June 2, 2015

**RE: Paseo del Norte Sports Complex, Tract A, Loop Industrial Park
Grading and Drainage Plan
Engineer's Stamp Date 5-20-2015 (File: C17-D008)**

Re: Paseo Del Norte Sportsplex, Hydrology Re-Submittal

date
5-20-15
sheet
c001

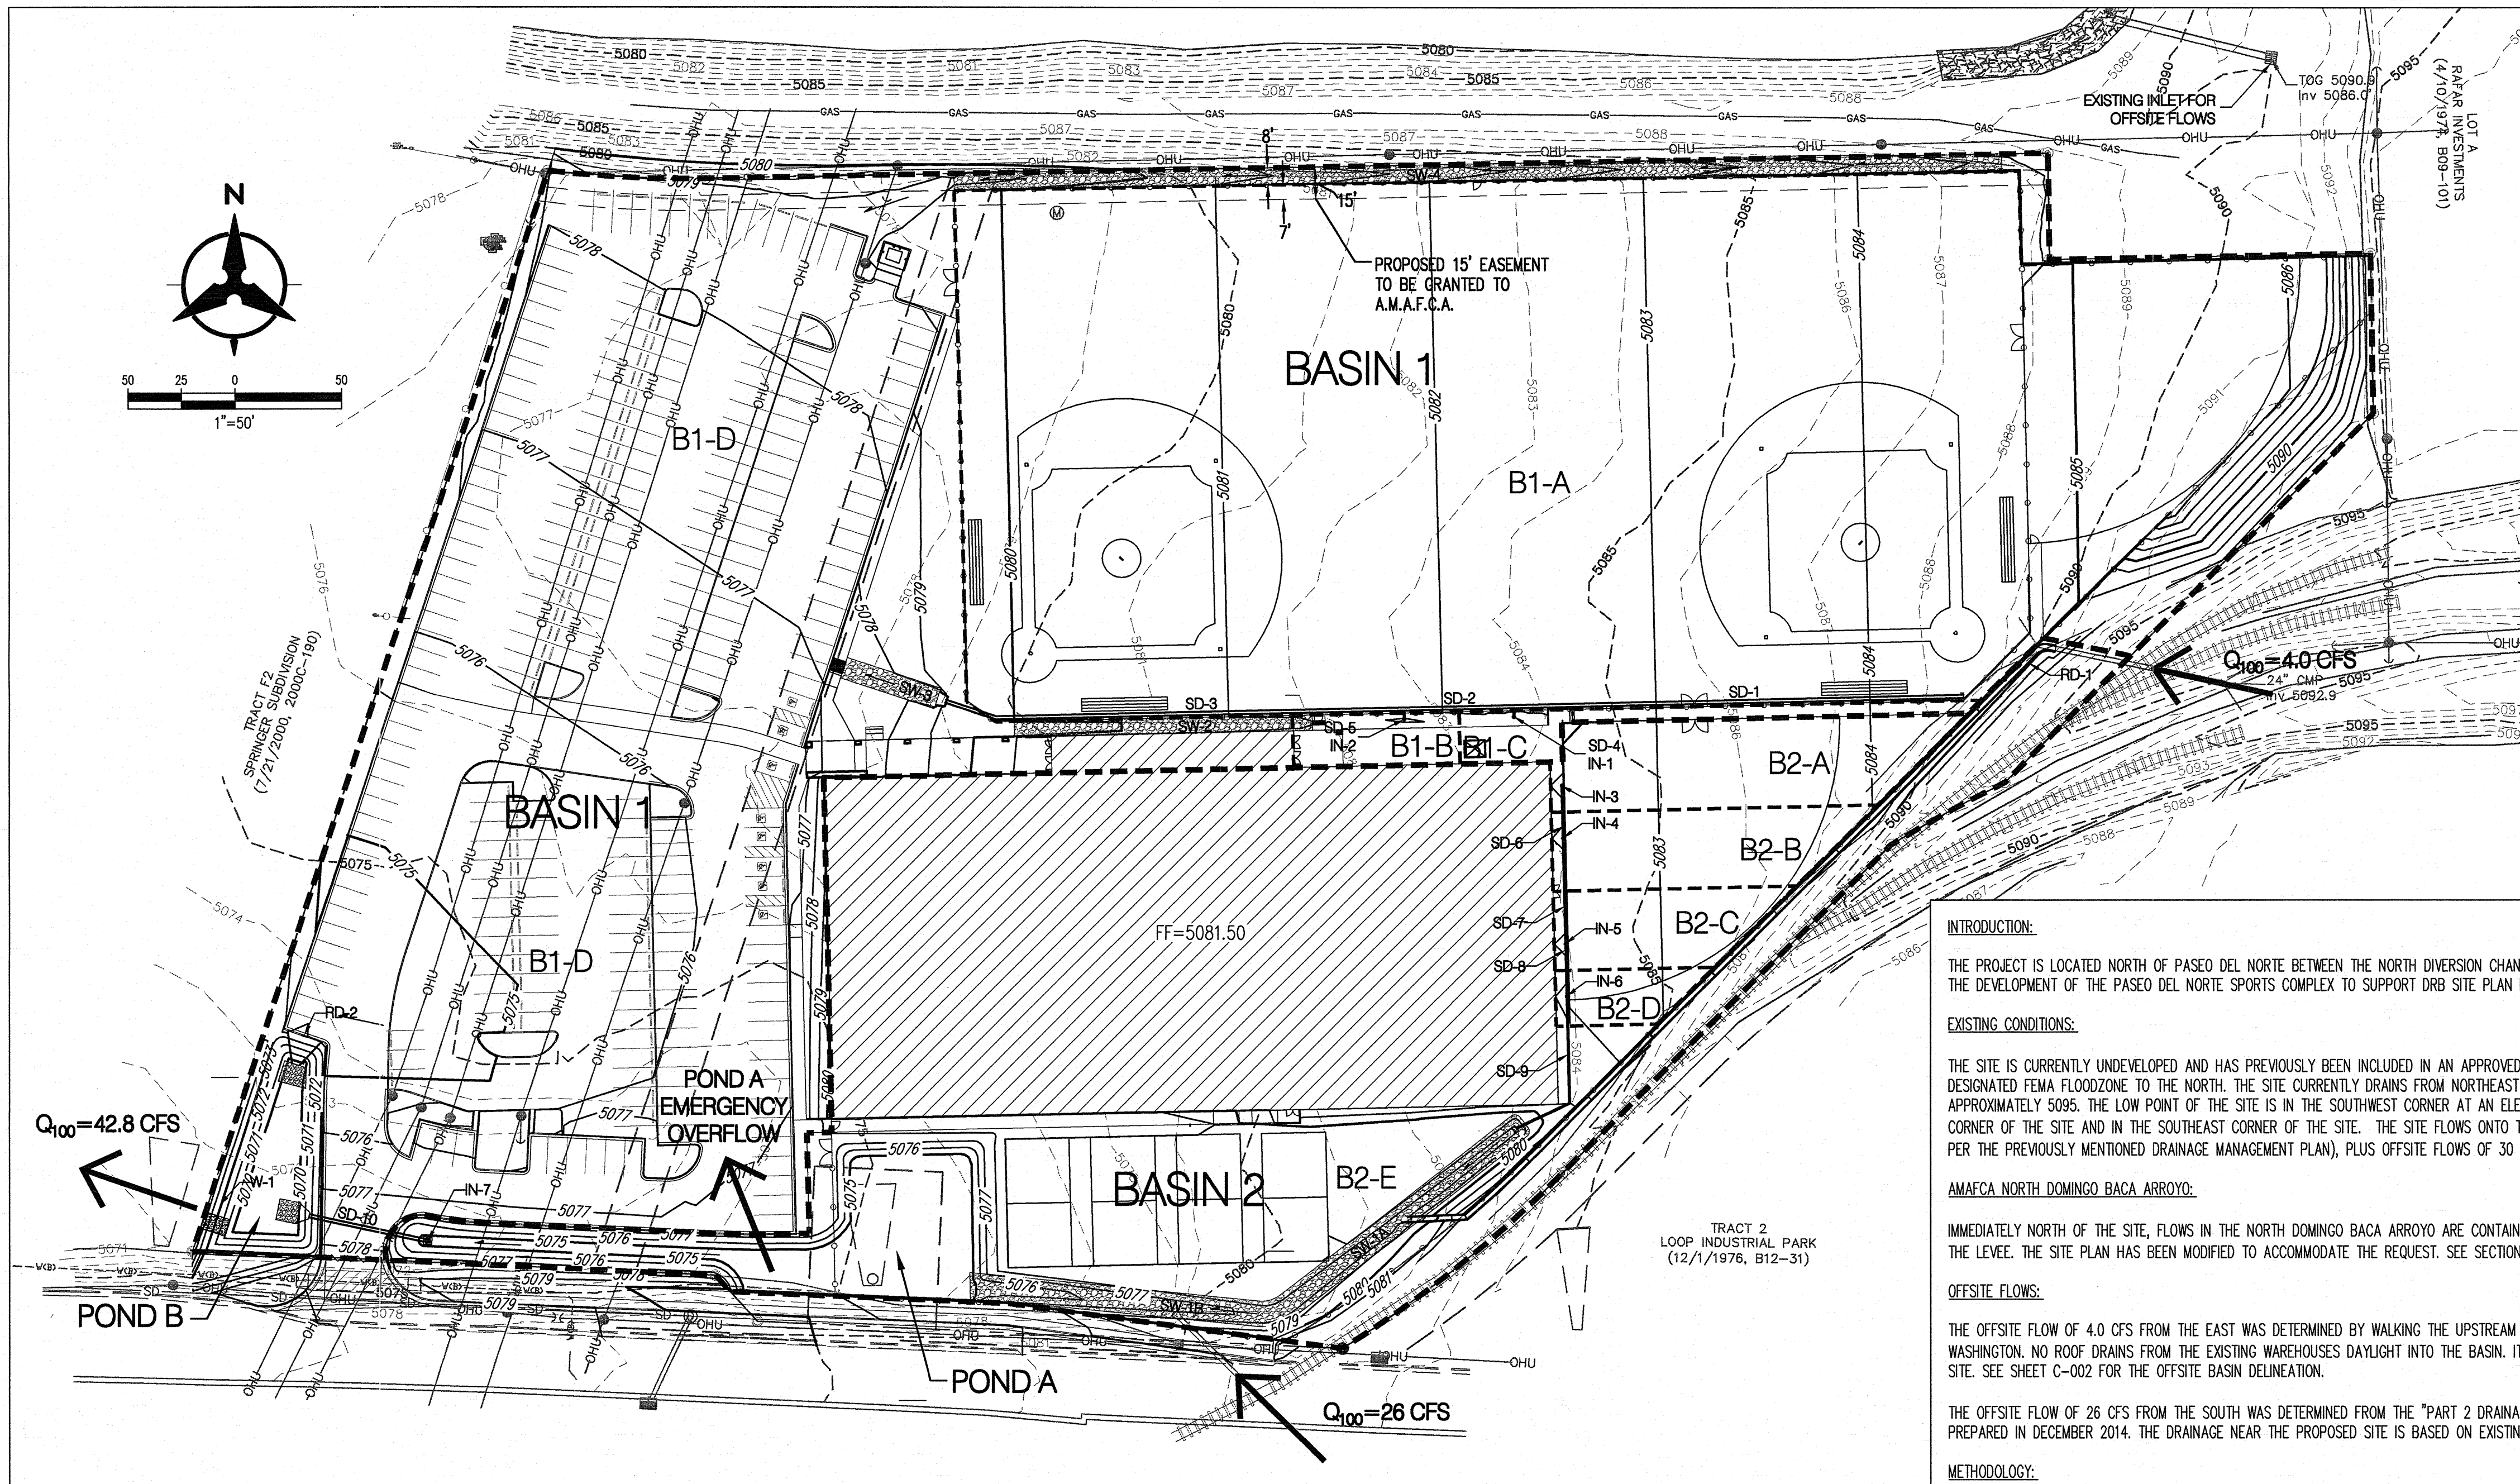
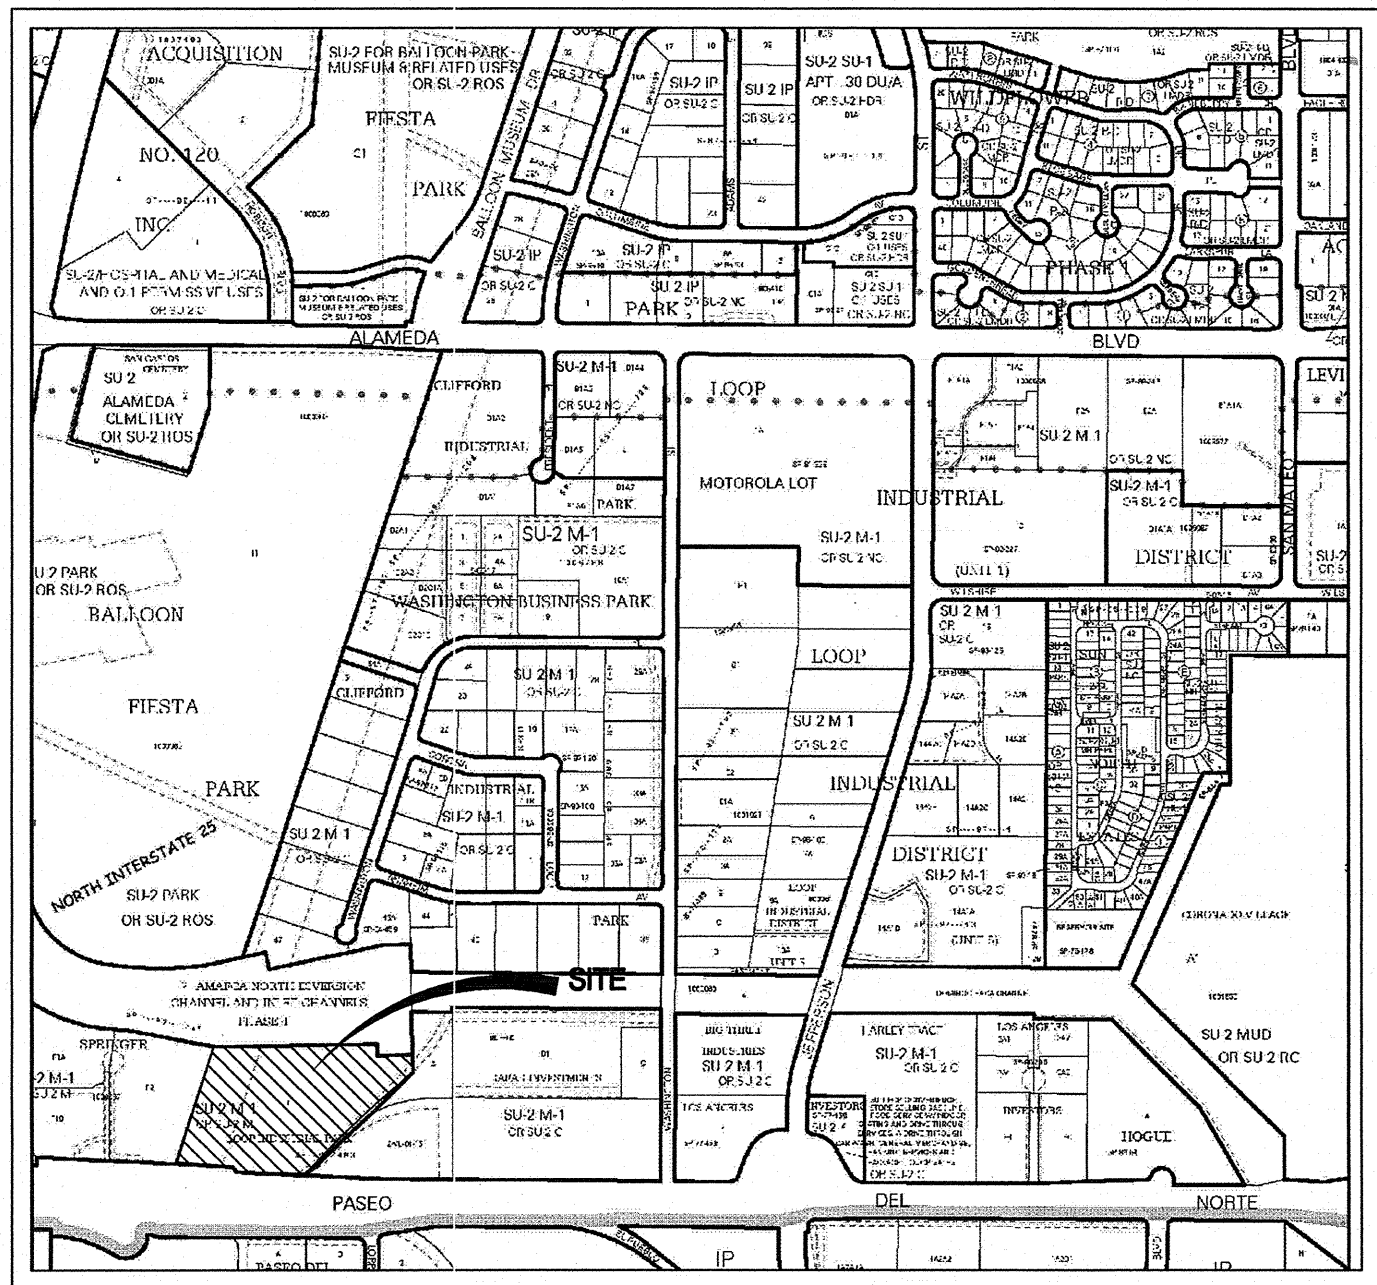
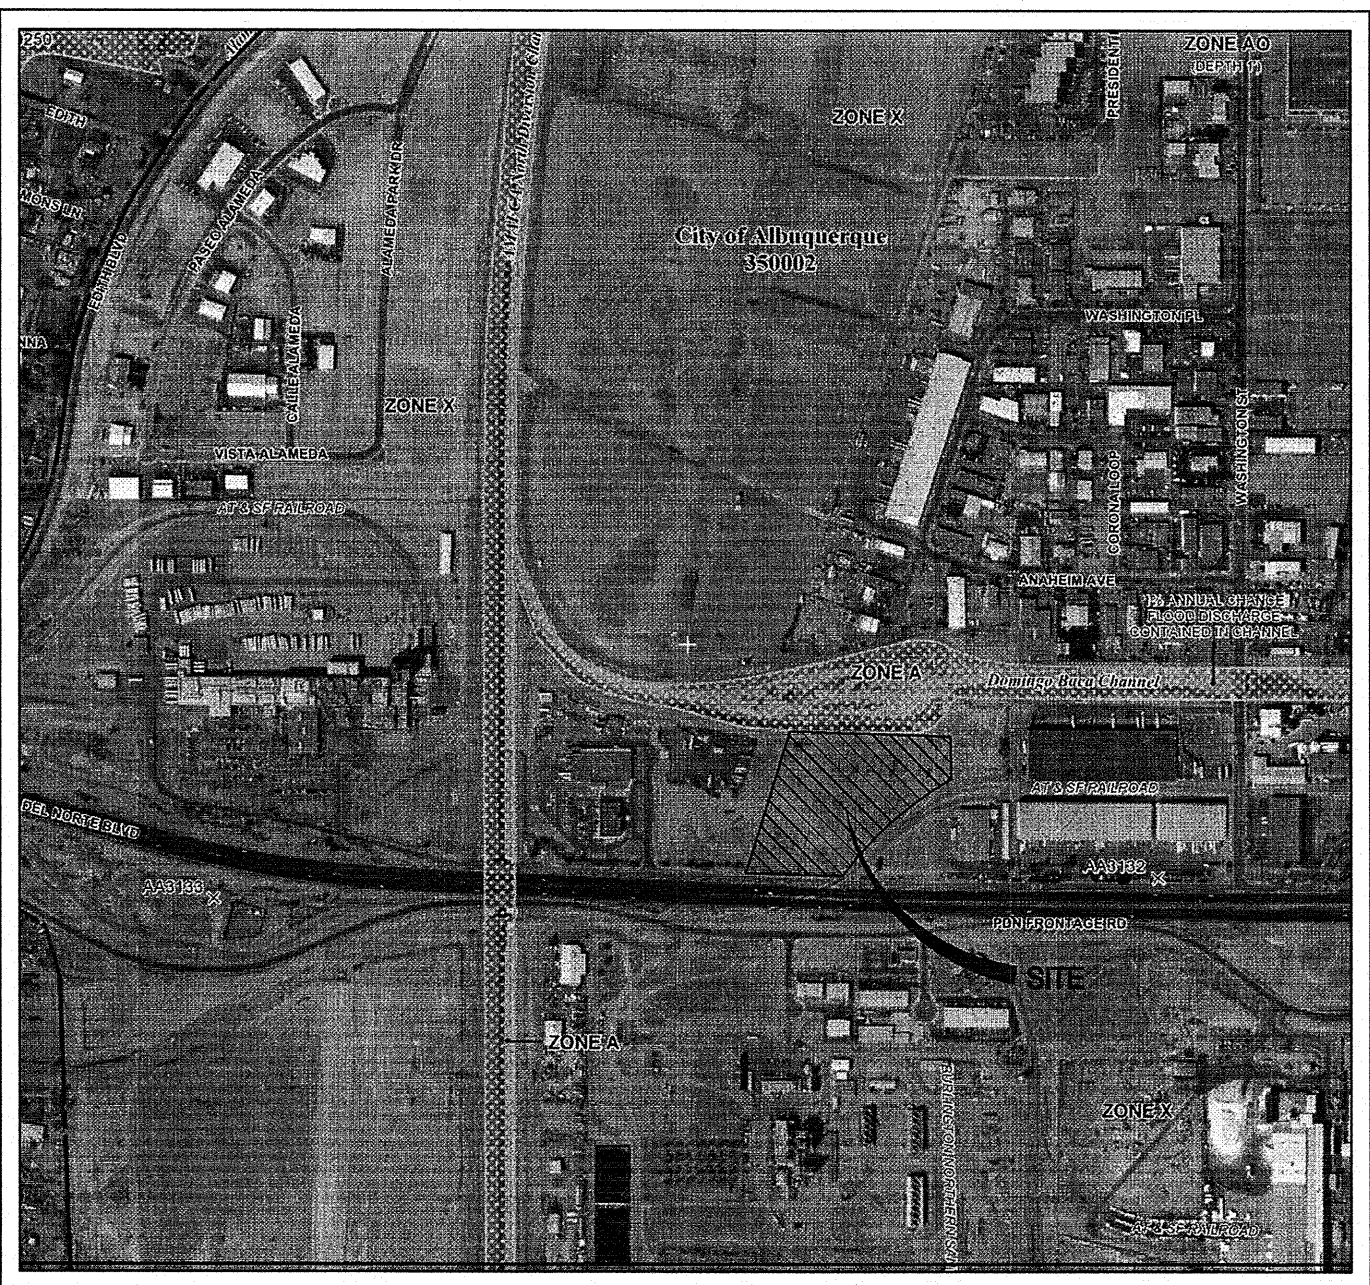
- 2) Make sure that the water surface elevation within the AHYMO run matches what is shown on Sheet C-001, and also provide the required and provided storage volumes along with the WSEL information. (There is a minor discrepancy of 77.28 in the AHYMO versus 77.41 on the plans for Pond "A".)

7) Provide concrete rundown details for rundowns R1 and R2. Also, make reference to them on Sheet C-001 by the same designation. (You have them called out as "RD-1", "RD-2", etc.)
